**SCHEDULE OF AMENDMENTS TO  
THE APPROVED LUNG YEUK TAU AND KWAN TEI SOUTH  
OUTLINE ZONING PLAN NO. S/NE-LYT/17  
MADE BY THE TOWN PLANNING BOARD  
UNDER THE TOWN PLANNING ORDINANCE (Chapter 131)**

**List of Representers and Commenter in respect of the  
Draft Lung Yeuk Tau and Kwan Tei South Outline Zoning Plan No. S/NE-LYT/18**

**AMENDMENTS TO THE LUNG YEUK TAU AND KWAN TEI SOUTH OZP NO. S/NE-LYT/17  
and HOK TAU OUTLINE ZONING PLAN NO. S/NE-HT/5**

就龍躍頭及軍地南分區計劃大綱草圖編號S/NE-LYT/18  
提出的申述個案編號R1至R2以及相關意見個案編號C1作出考慮  
CONSIDERATION OF REPRESENTATIONS No. R1 TO R2 AND RELATED COMMENT No. C1  
DRAFT LUNG YEUK TAU & KWAN TEI SOUTH OUTLINE ZONING PLAN No. S/NE-LYT/18

圖則編號 PLAN No. S/NE-LYT/18

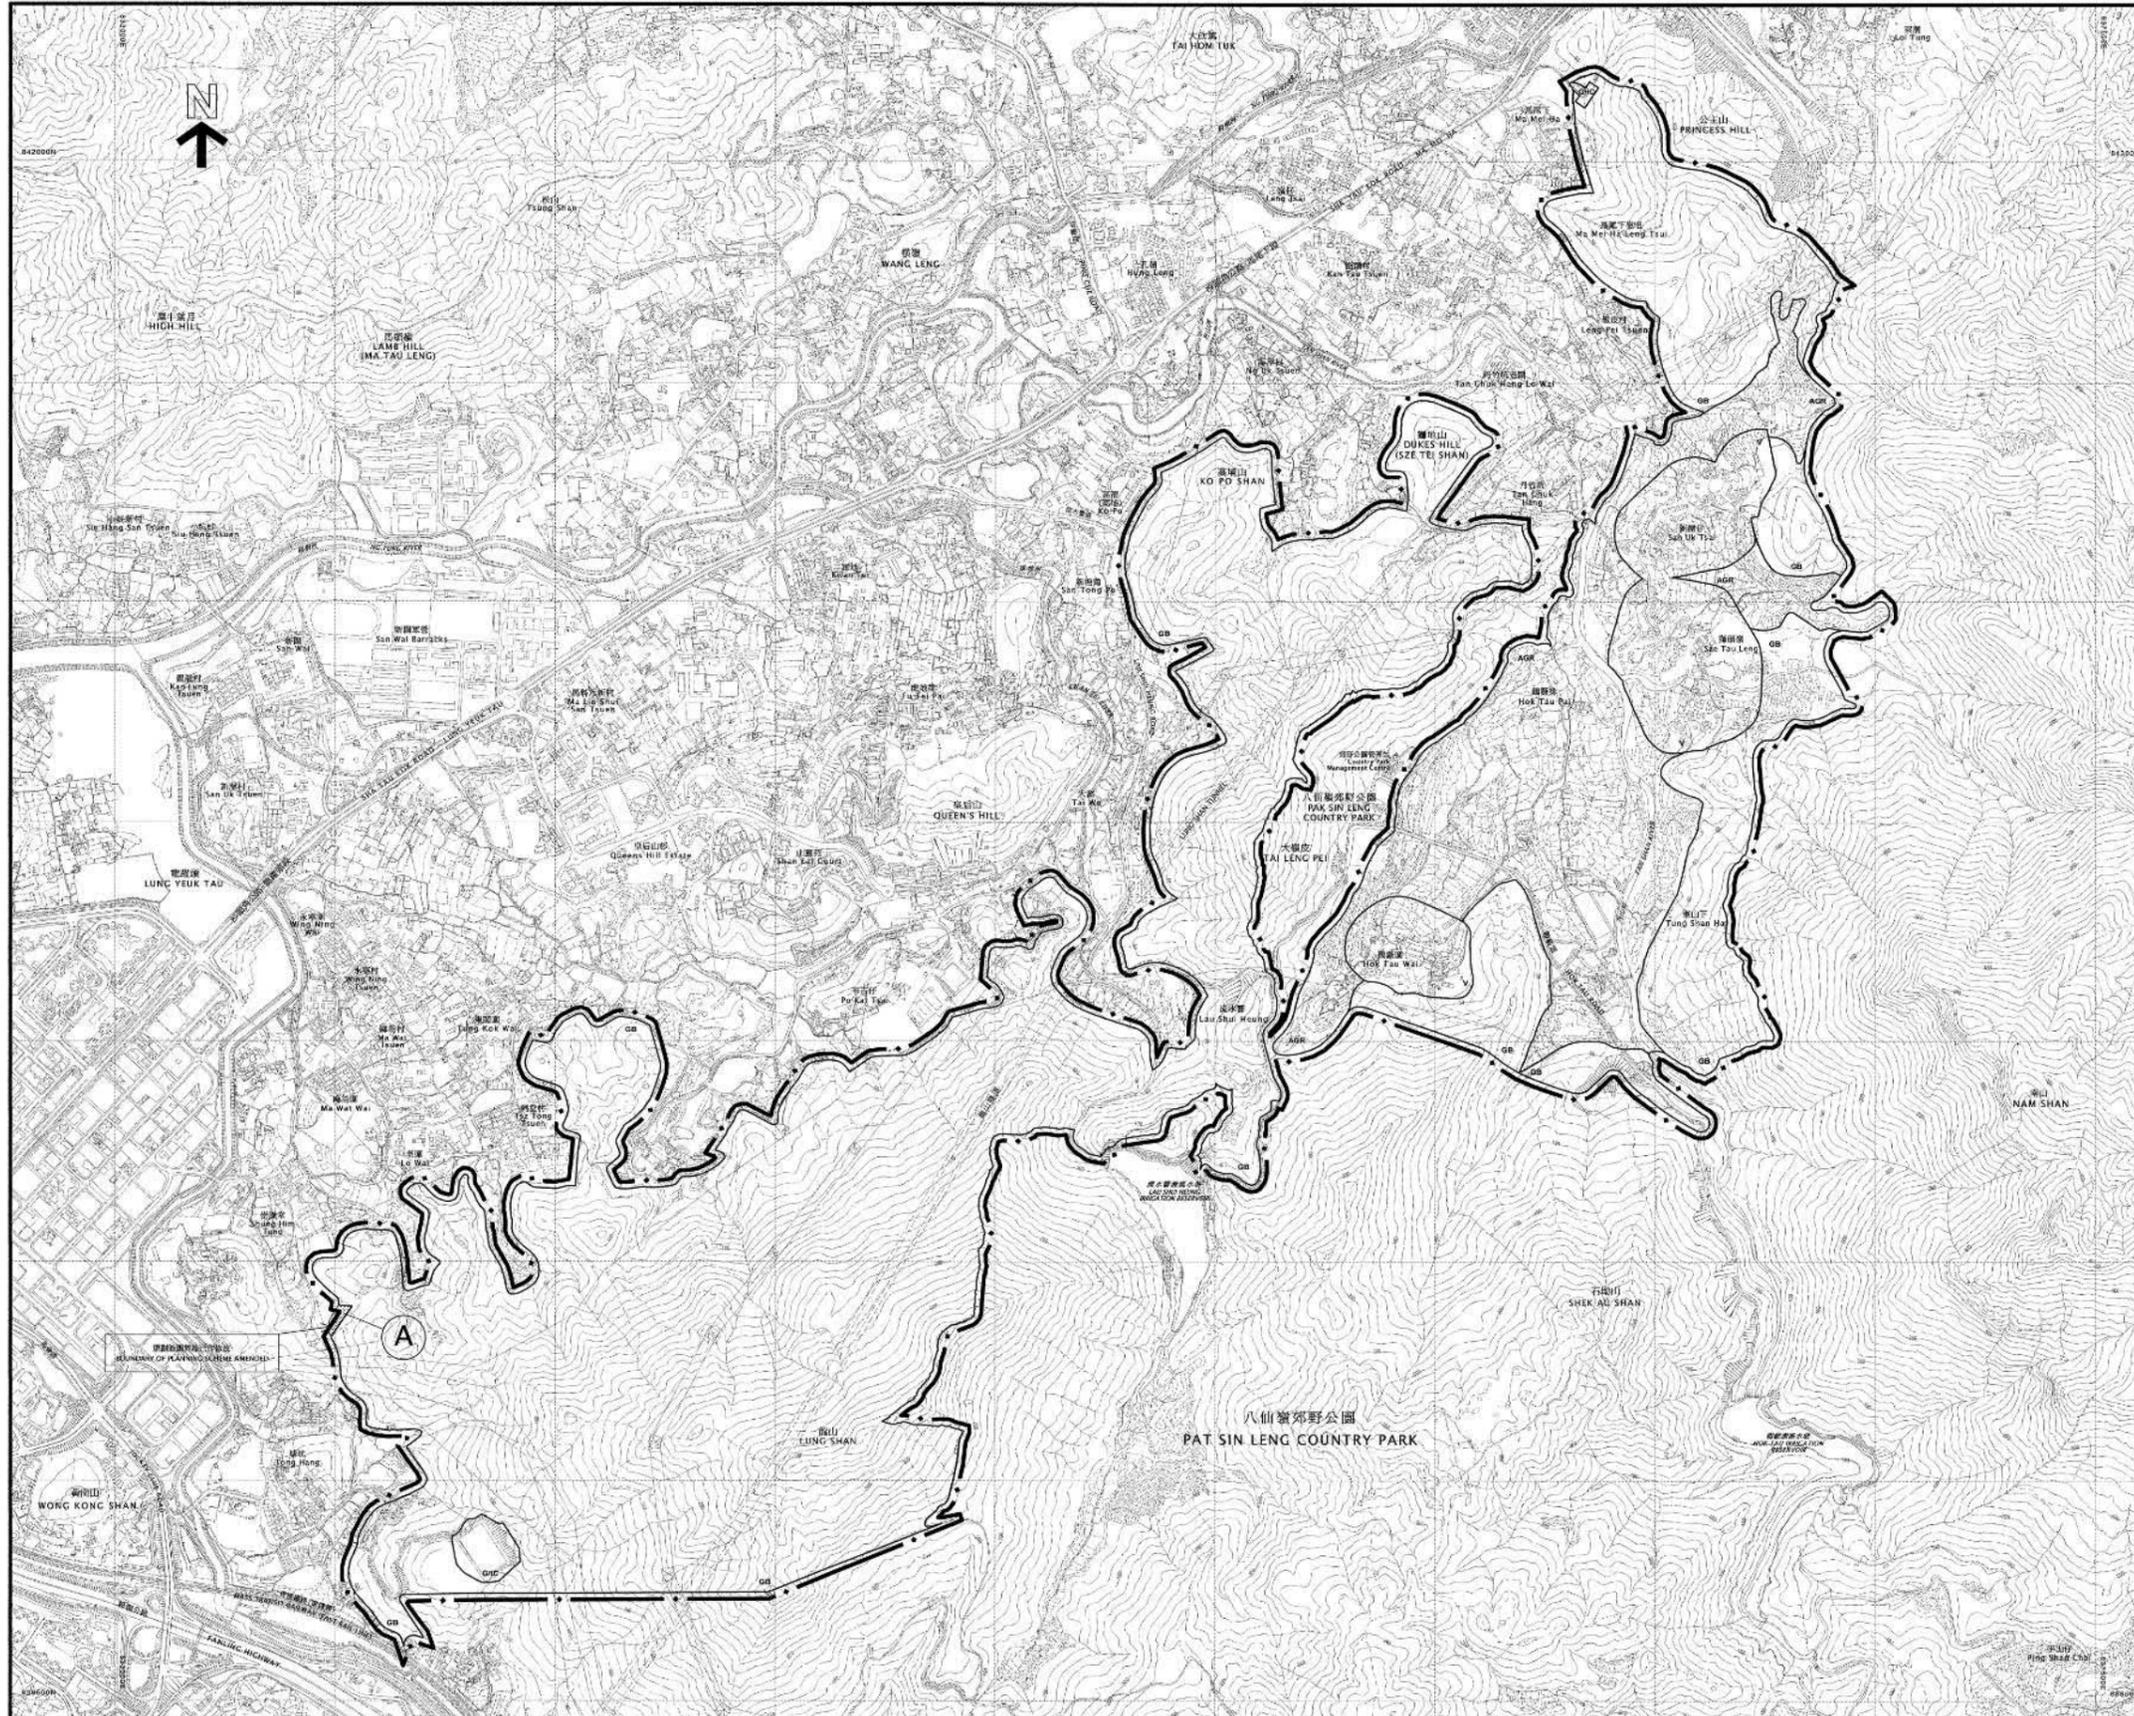
**Item A1** – (about 4.14 ha) Rezoning of a site to the north of Shan Lai Court from “Res (Group B) to “Res (Group A)1” with stipulation of BHR 175mPD / PR 7

**Item A2** - Rezoning of a site to the north of Shan Lai Court from “Res (Group A)” to “R(A)1” with stipulation of BHR 175mPD / PR 7

*The ex-Burma Lines Military Site (known as the Queen’s Hill Site) was rezoned in 2015 from G/IC(2)” to “Res (Group A)” for public housing development (now Queens Hill Estate and Shan Lai Court), “Res (Group B)” for medium-density private housing development, international school and district open space. The Government has decided to allocate the “R(B)” site for public housing purpose.*

The rezoning should come with stringent conditions with regard to any expansion plans. The niches are a relatively recent commercial addition to the original cemetery.

- Item A1 – Rezoning of a site to the north of Shan Lai Court from “Residential (Group B)” (“R(B)”) to “Residential (Group A)1” (“R(A)1”) with stipulation of building height restriction.
- Item A2 – Rezoning of a site to the north of Shan Lai Court from “Residential (Group A)” (“R(A)”) to “R(A)1” with stipulation of building height restriction.
- Item B – Incorporation of a piece of land to the south-east of Shung Him Tong Village from the approved Hok Tau Outline Zoning Plan No. S/NE-HT/5 into the planning scheme area, and rezoning that piece of land together with its adjoining land to the west from “Green Belt” and “Agriculture” to “Other Specified Uses” annotated “Cemetery” (“OU(Cemetery)”).

SHEET TITLE  
 PHOTOMONTAGE - VIEWPOINT 5

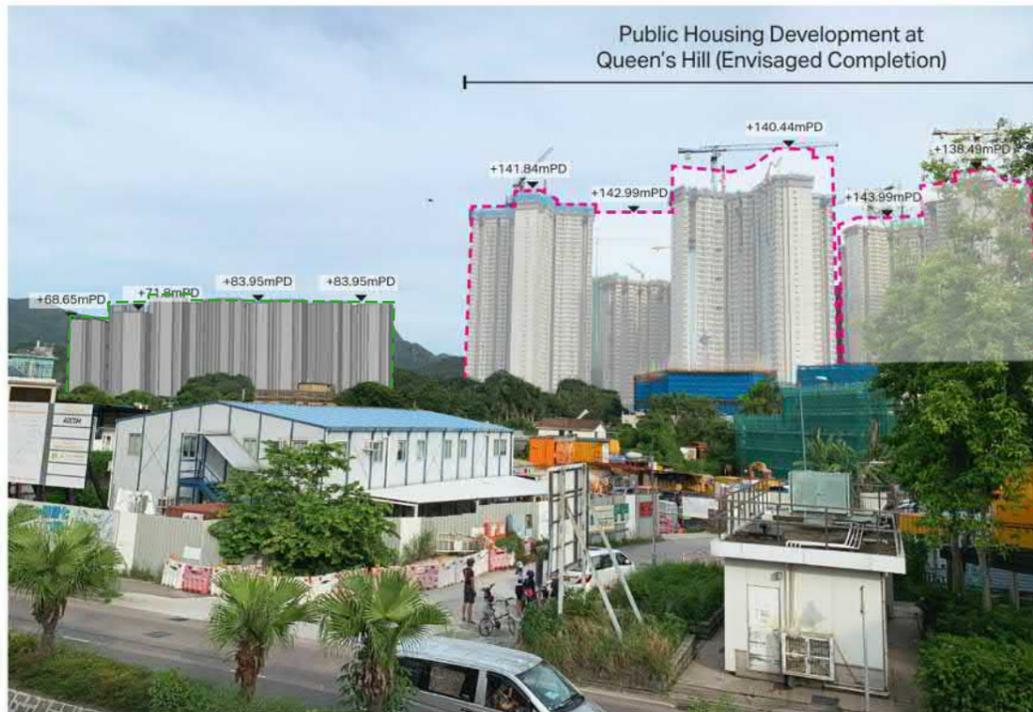
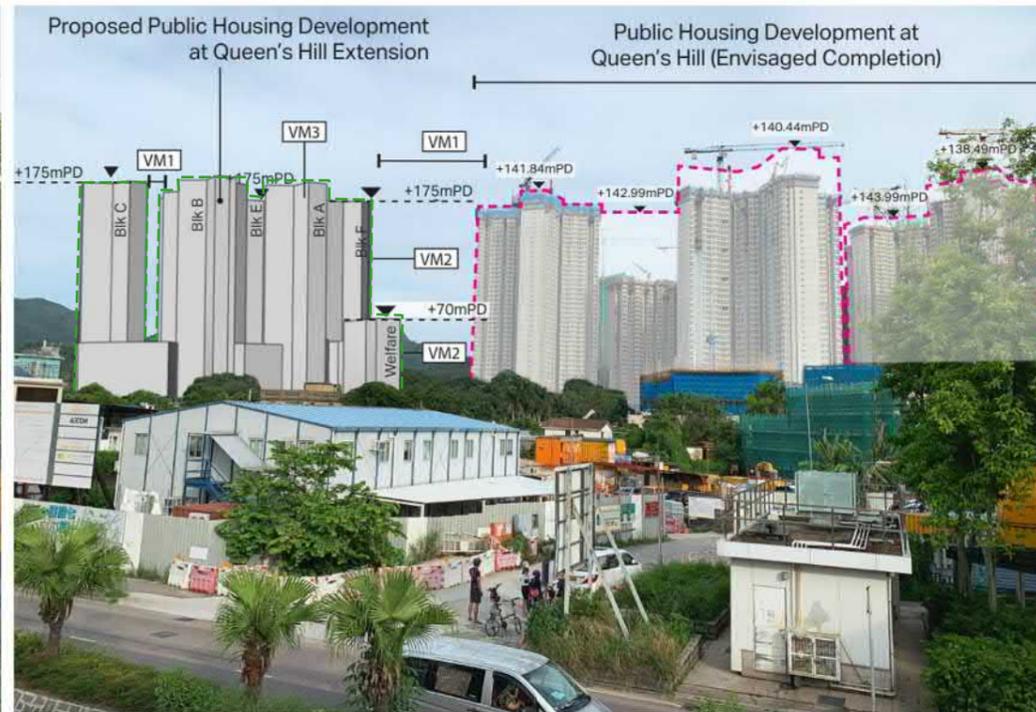
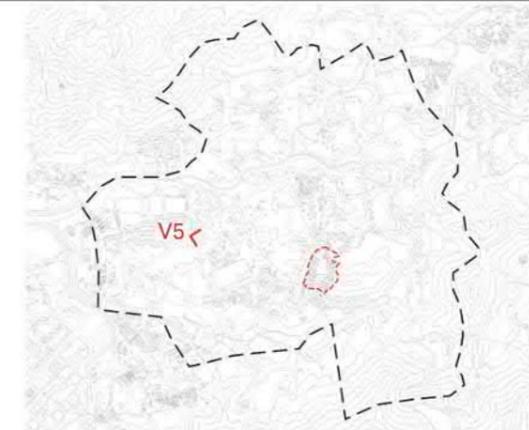
*Whilst one viewing point is graded 'significantly adverse' at Sha Tau Kok Road footbridge (Plan 9e), the view point is transient in that visual sensitivity to footbridge users or travelers is relatively lower **due to shorter visual duration**.*

Seriously, this is a wall of towers, nothing can mitigate the impact.
